**DSO9254A-02**

# **S E R V I C E                      N O T E**

## **DSO9254A – 2.5 GHz Digitizing Oscilloscope**

**Intermittent power failure on some 9000 series units.**

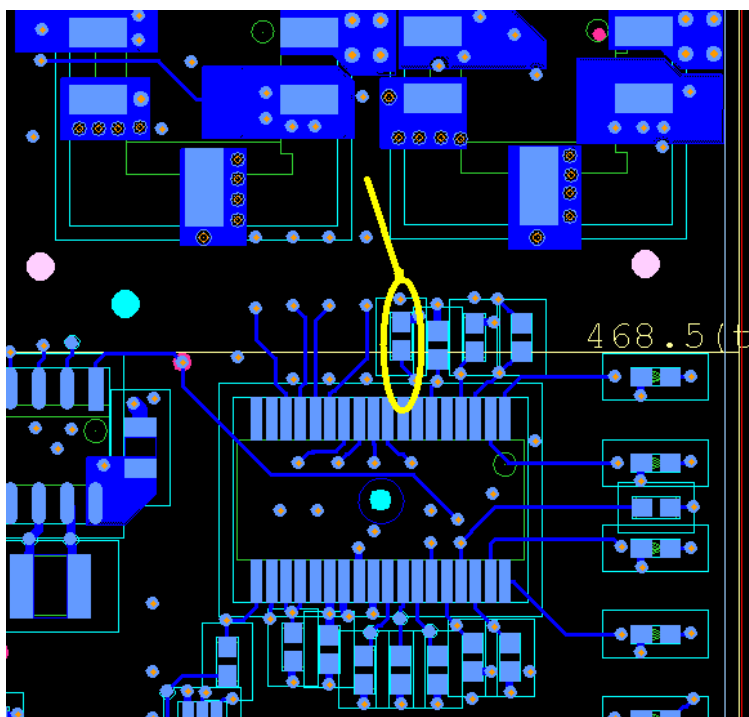
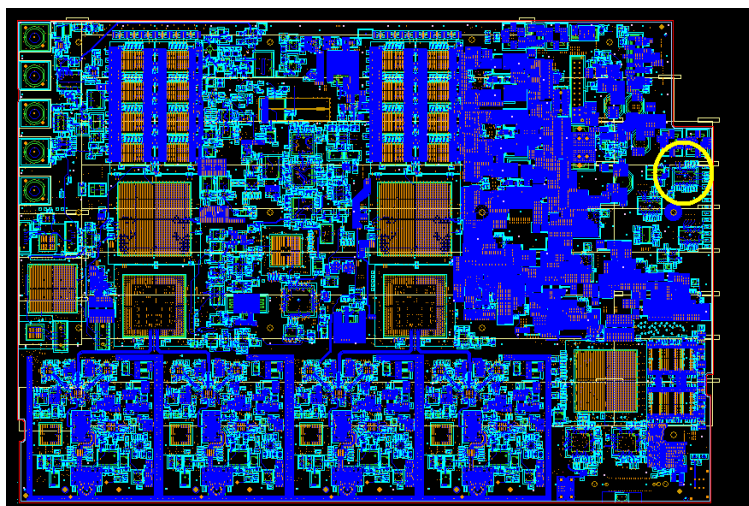
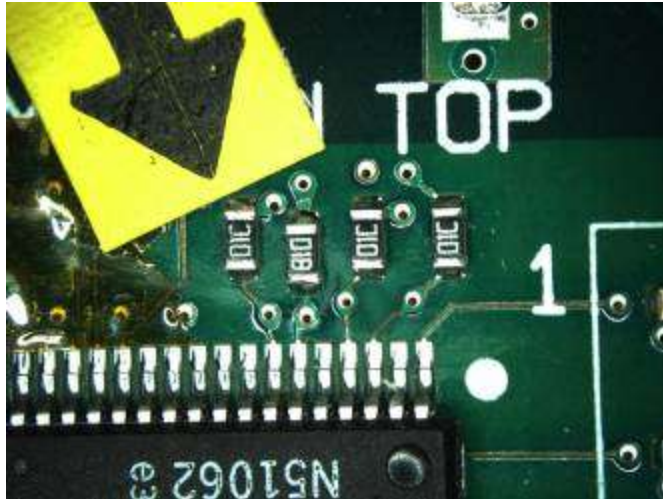
1. Use the disassembly instructions in the service manual to remove the acquisition board.
2. Refer to the below drawings to identify R2830. The area of interest is marked with a yellow circle

Before modification

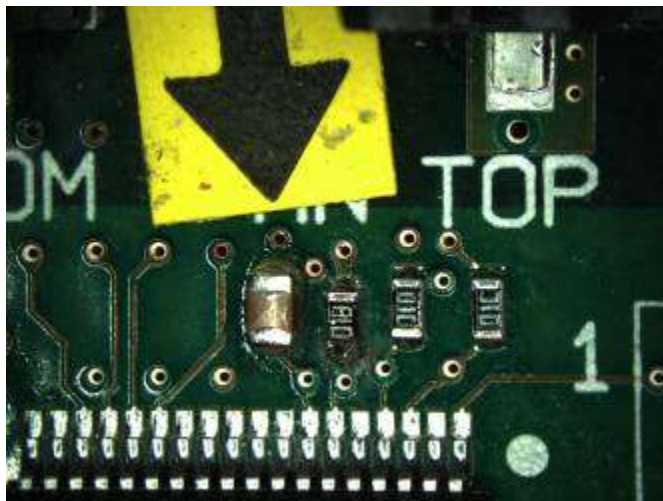
3. Remove existing 10K resistor R2830.
4. Clean the solder pad and install the 10.5K SMD resistor on the pad.
5. Solder the 220nF SMD capacitor on top of the 10.5K resistor as shown in the below picture. Make sure the solder overflows down to the resistor pad entirely. A poorly soldered capacitor won't work as a capacitor.
6. Check the quality of your work by using a multimeter probe tip. Gently touch the lower pad of the capacitor several times. The probe tip introduces enough noise to turn the scope off if the capacitor is not soldered correctly. The capacitor forms a low pass filter to reduce noise. If the capacitor is soldered correctly, noise will not cause the scope to turn off.

Bulk power supply cable and on/off cable routing

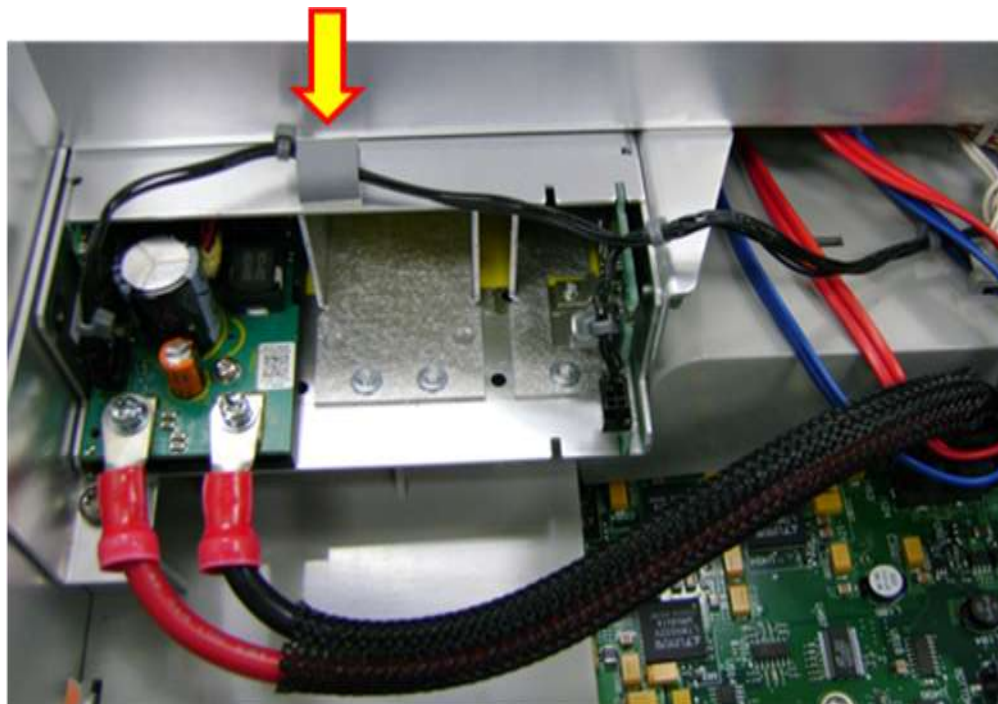
7. Install the acquisition board back into the scope.
8. Refer to the below picture and dress the bulk power supply cables as shown.
9. Install clip on sheet metal as shown and dress the on/off cable through clip.
